FCC ID: B7JDJCRVSIII
IC: 5682A-DJCRVSIII
Model: 46783

We are requesting a Class II Permissive change for our DICKEY-john RVS III ground speed radar (K-band microwave 24.125GHz), see below description of the change:

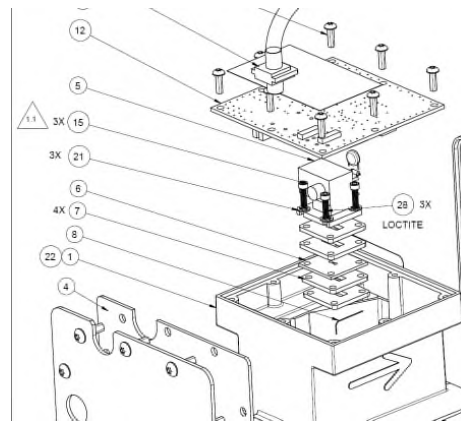
The originally tested design includes a harmonic filter plate (part 6) between the transceiver and the antenna waveguide. What we have found is that we get better signal to noise at our mixing diode if we extend the waveguide slightly. We accomplish this by adding four spacer plates (part 7) between the transceiver and antenna waveguide, keeping the harmonic filter.

Increasing the waveguide length doesn't impact our power output or antenna characteristics, it only repositions the peaks of the standing wave in the waveguide so that a peak occurs at our mixing diode. This improves our sensitivity to the returned signal. As an additional verification we have performed Harmonic testing with TUV SUD America (project #: SD72120079-0916 Dickey-John) and results are within specification.
